PACIFIC GAS AND ELECTRIC COMPANY
DIABLO CANYON NUCLEAR POWER PLANT, UNIT 1
DOCKET NO. 50-275
AMENDMENT TO FACILITY OPERATING LICENSE

Amendment No. 10
License No. DPR-80

ATTACHMENT TO LICENSE AMENDMENT NOS. 10 AND 8
FACILITY OPERATING LICENSE NOS. DPR-80 AND DPR-82
DOCKET NOS. 50-275 AND 50-323

Revise the following pages of the Appendix A Technical Specifications with the enclosed pages. The revised pages are identified by Amendment Number and contain vertical lines indicating the area of change.

FIGURE 2.1-1a
REACTOR CORE SAFETY LIMIT (UNIT 1)

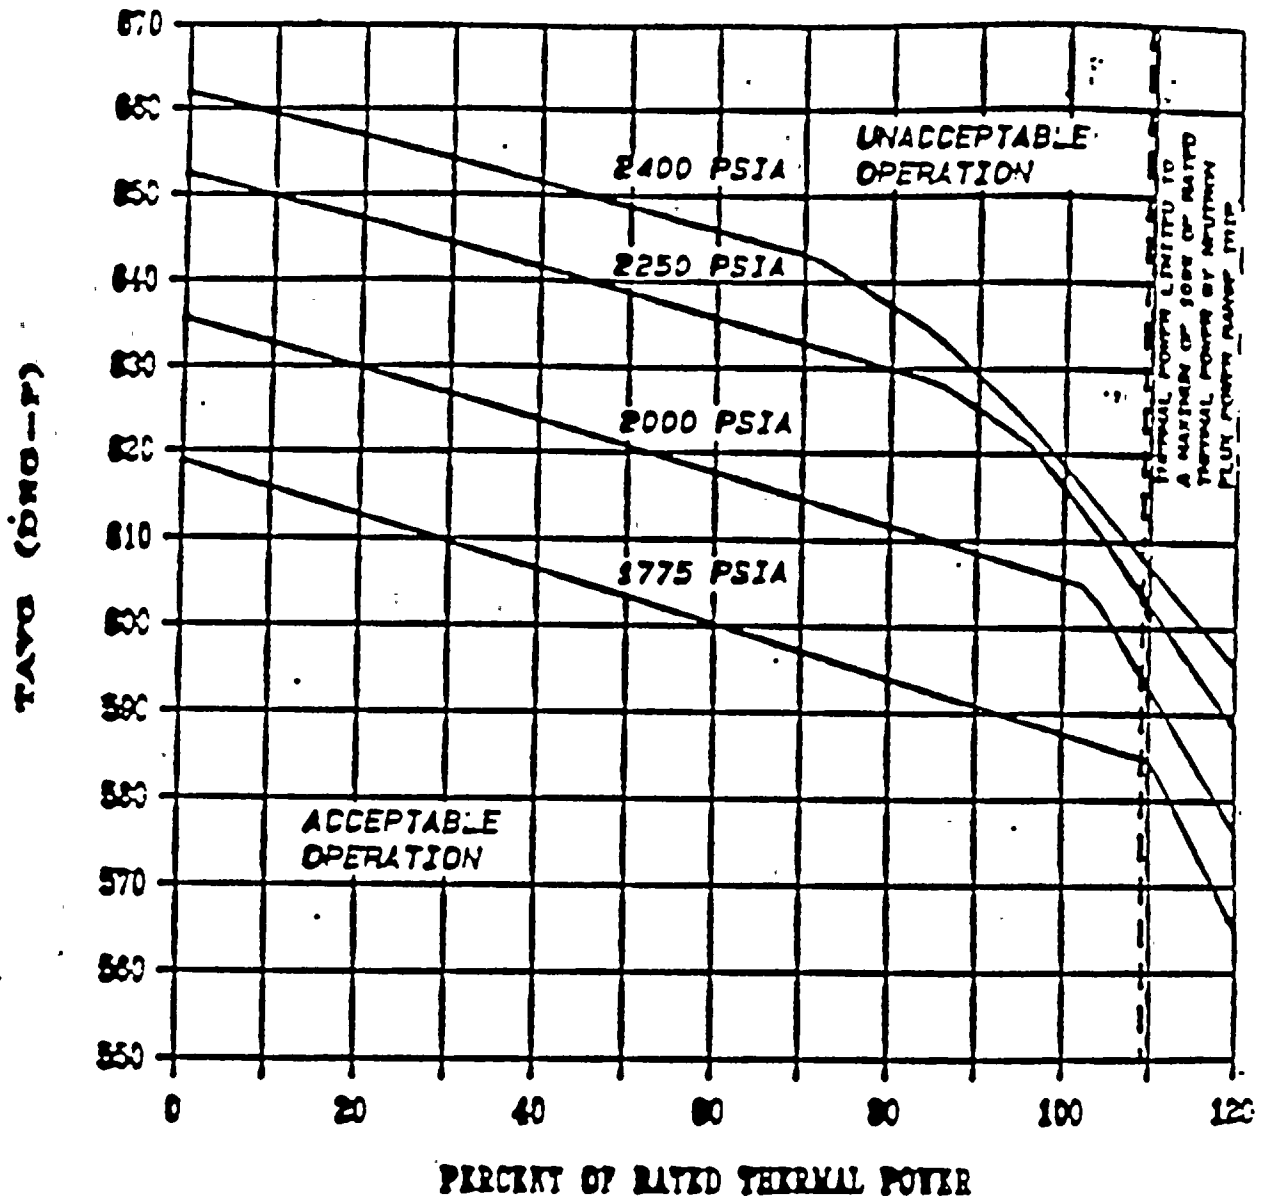
2.1.1 The combination of THERMAL POWER, pressurizer pressure, and the highest operating loop coolant temperature (T_{avg}) shall not exceed the limits shown in Figure 2.1-1a for Unit 1 and Figure 2.1-1b for Unit 2.

FIGURE 3.2-3a

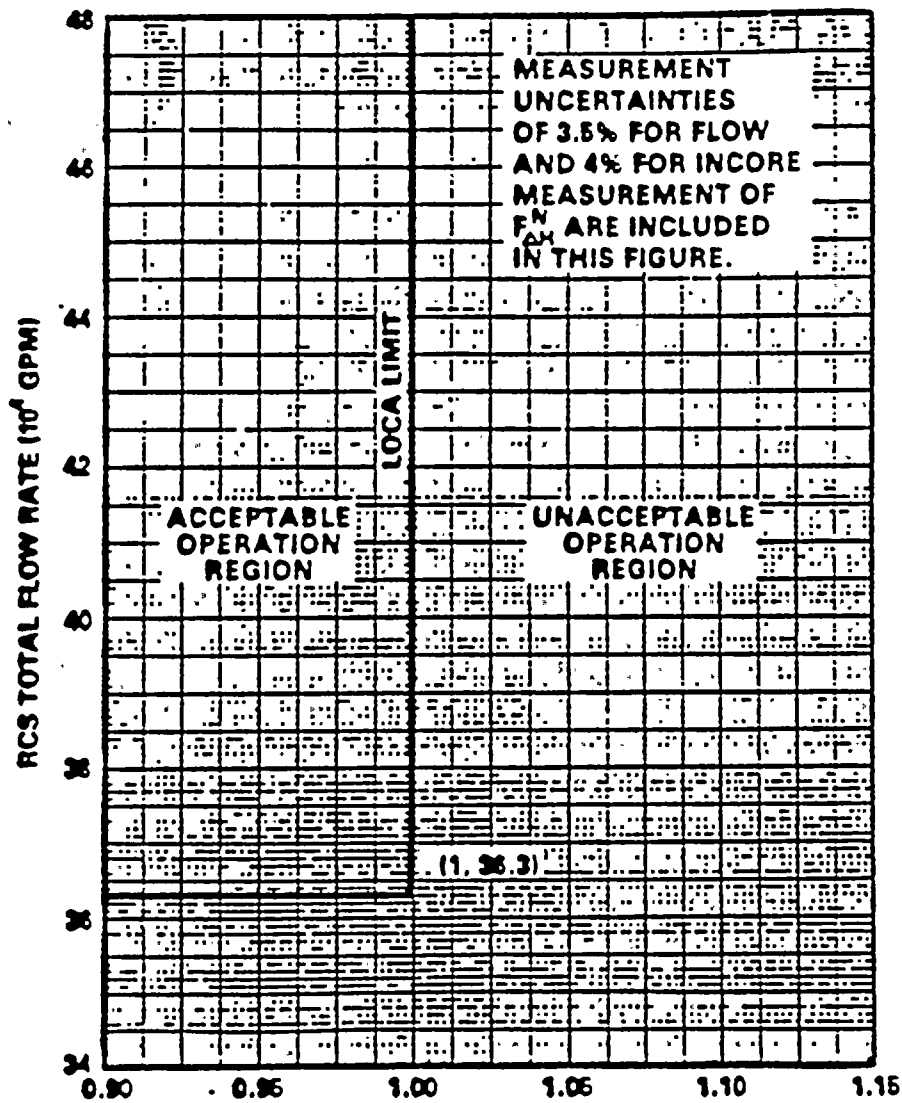
3.2.3 The combination of indicated Reactor Coolant System (RCS) total flow rate and R shall be maintained within the region of allowable operation shown on Figure 3.2-3a for Unit 1 and Figure 3.2-3b for Unit 2 for four loop operation.

c. $F_{\Delta H}^N$ = Measured values of $F_{\Delta H}^N$ obtained by using the movable incore detectors to obtain a power distribution map. The measured values of $F_{\Delta H}^N$ shall be used to calculate R since Figure 3.2-3a for Unit 1 and Figure 3.2-3b for Unit 2 include measurement uncertainties of 3.5% for flow and 4% for incore measurement of $F_{\Delta H}^N$.
